Petition No. 1312
Candlewood Solar LLC
197 Candlewood Mountain Road
New Milford, CT
Interrogatories

FIGURE
4

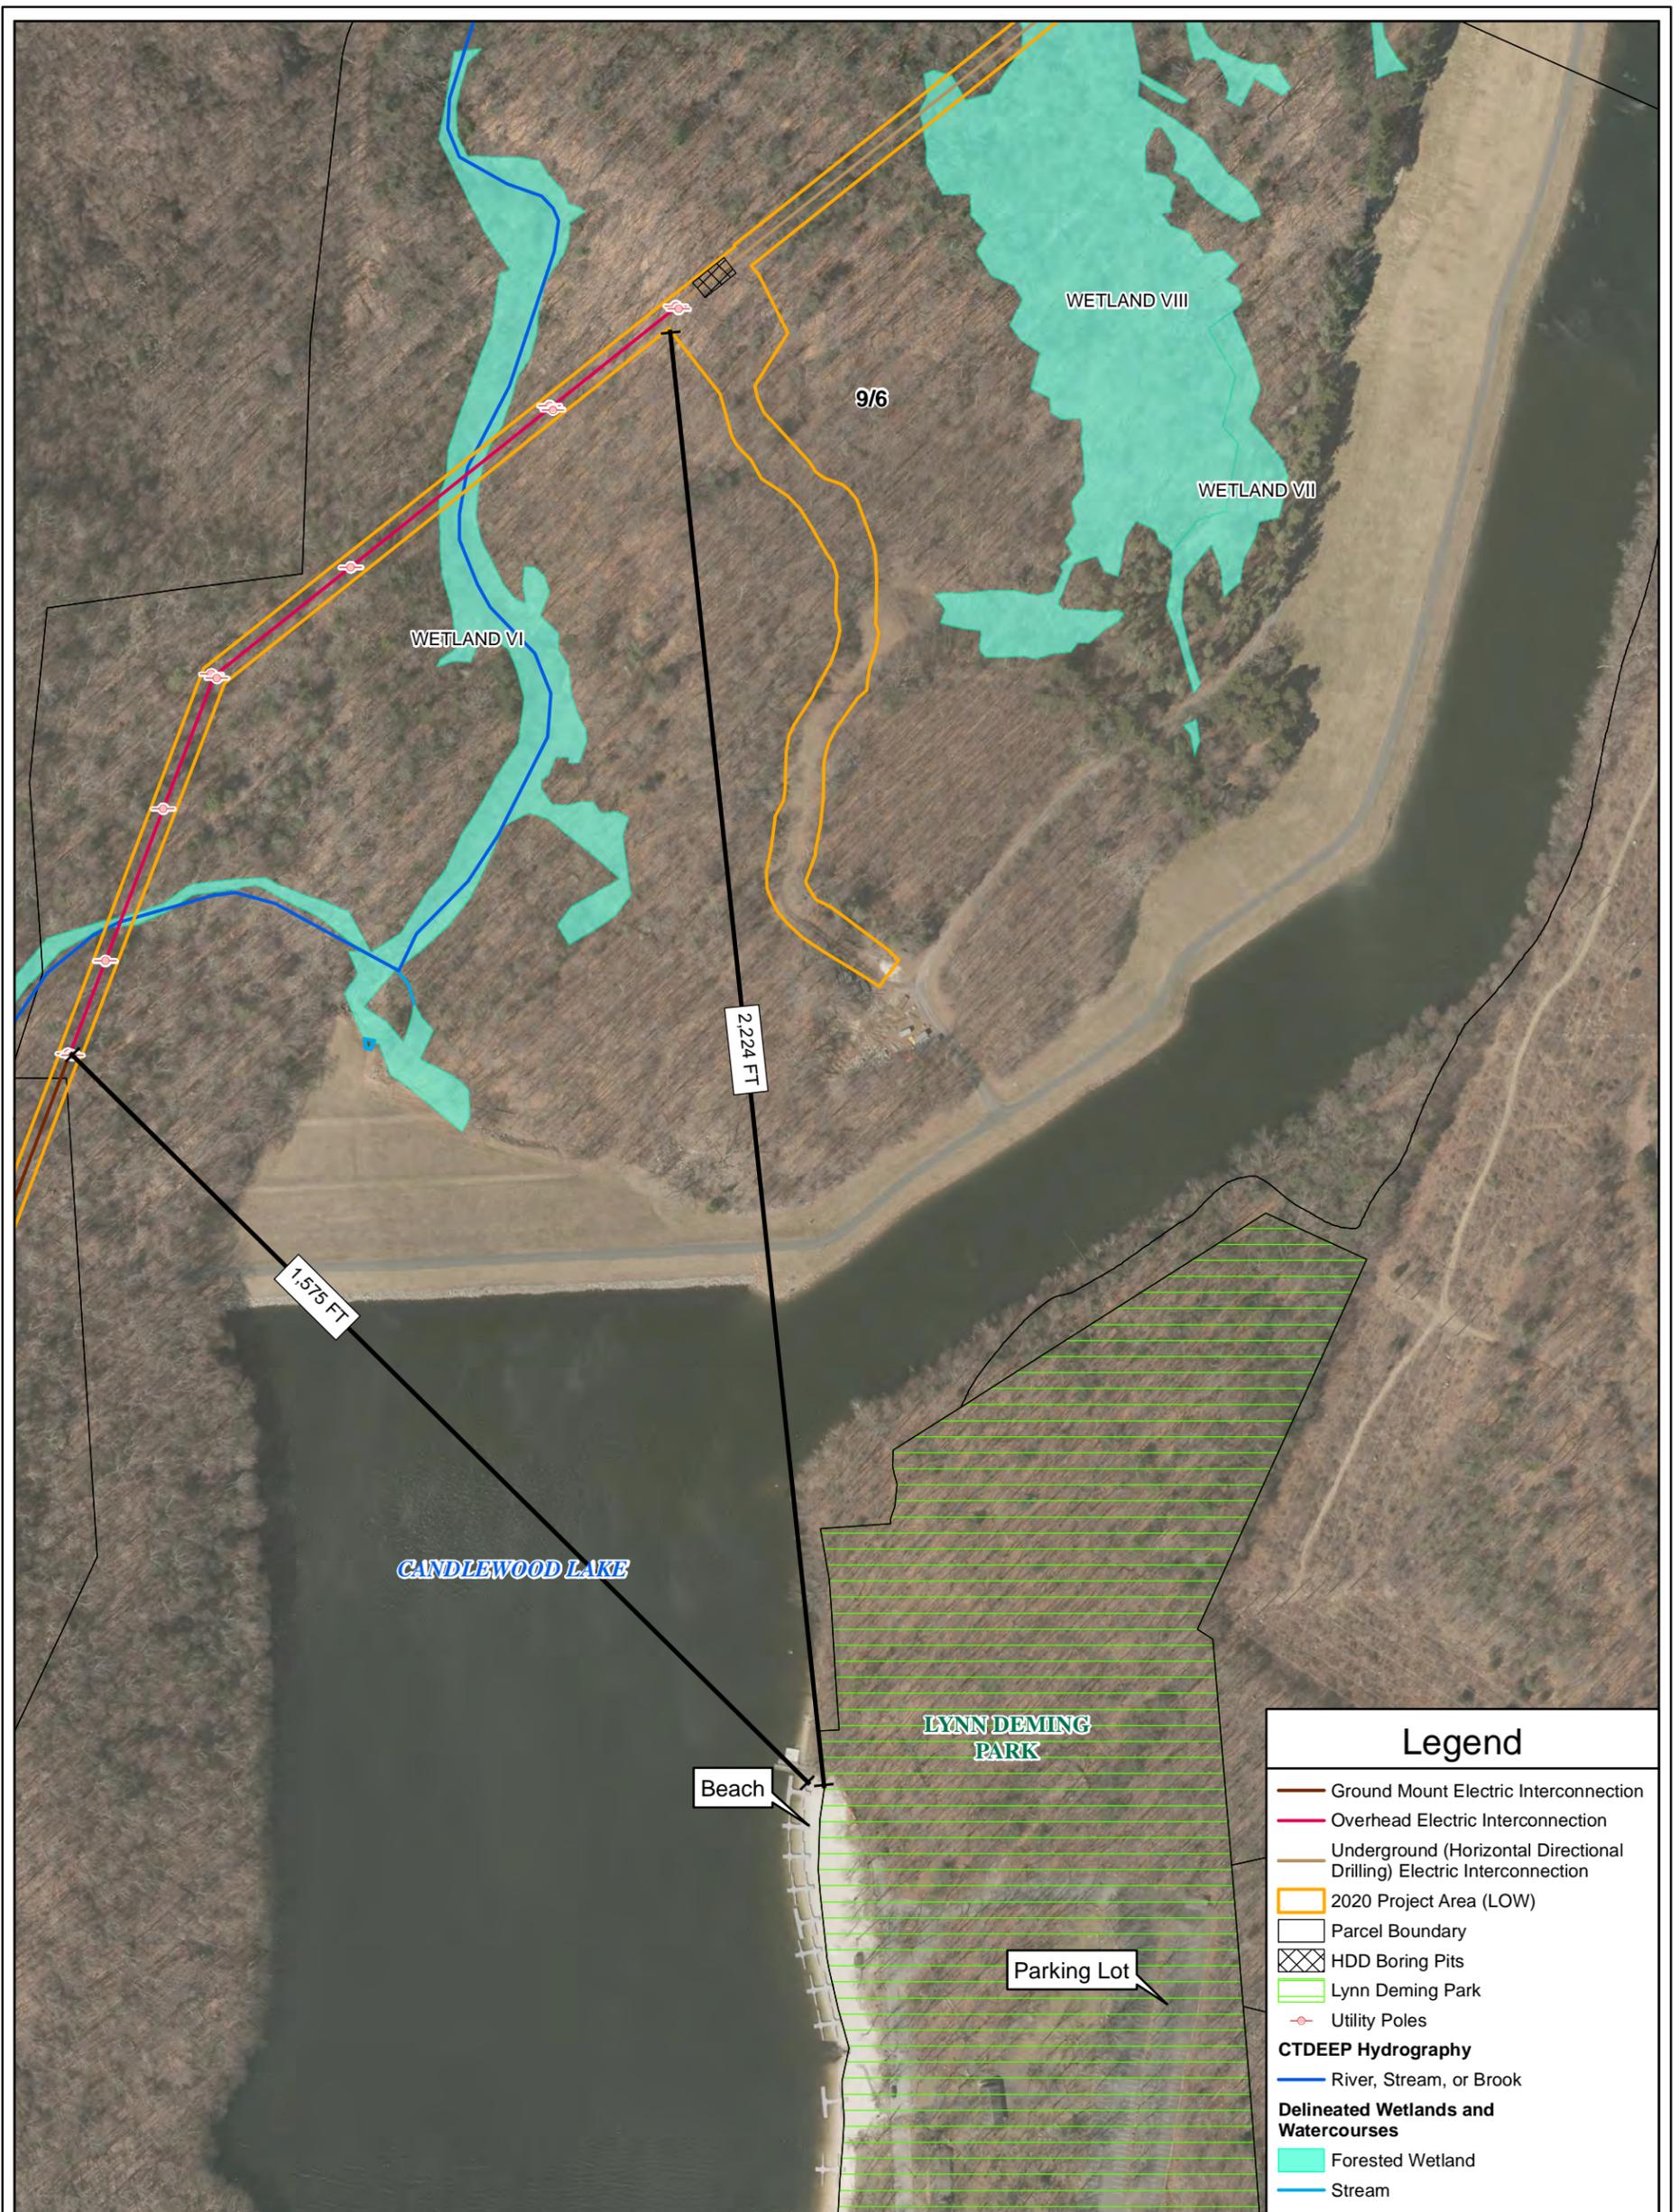
8. Would the proposed changes to the electrical interconnection in the D&M Plan Revisions affect the visibility of the electrical interconnection from Candlewood Lake or Lynn Deming Park? Explain.

In New Milford, Lynn Deming Park is located on the northeastern side of Candlewood Lake. The elevation at Lynn Deming Park is approximately 429 feet. The revised overhead segment from the Rocky River to first HDD boring pit is an additional 61 - 985 feet north of the previous interconnection route. Existing trees will remain between the revised overhead segment, Candlewood Lake and Lynn Deming Park (see Figure 3 and Figure 4). As such, Candlewood Solar does not anticipate that the revised overhead segment from the Rocky River to first HDD boring pit (7 utility poles or cleared approximate 30 foot swath) will be visible from Candlewood Lake or Lynn Deming Park.
